Summit Homes 120 SE 30th St. Lee's Summit, MO 64082

RE: Field Issue of city inspection for Lot #118 Reserve at Stoney Creek –1932 SW Hightown Drive, Lee's Summit, MO 64082 – Permit # PRRES20216204

Deck ledger attachment:

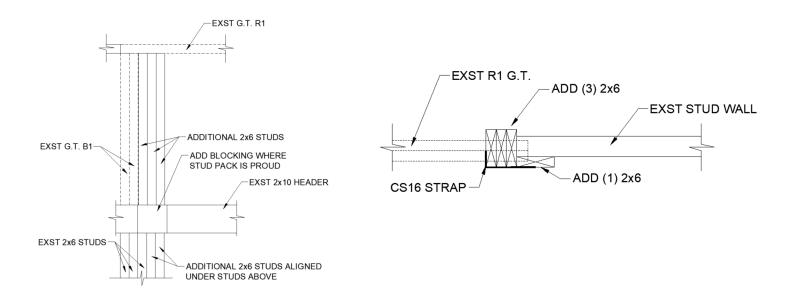
- Through bolts were installed with only one bolt per joist bay.
- Required spacing/pattern could not be met due to deck beam placement being too low.

- Install (1) additional through bolt to each joist bay.
- Through bolts shall be a minimum of 2" from the top edge, $\frac{3}{4}$ " from the bottom edge, no closer than 1 5/8" but no further than 5" vertically from adjacent bolts.
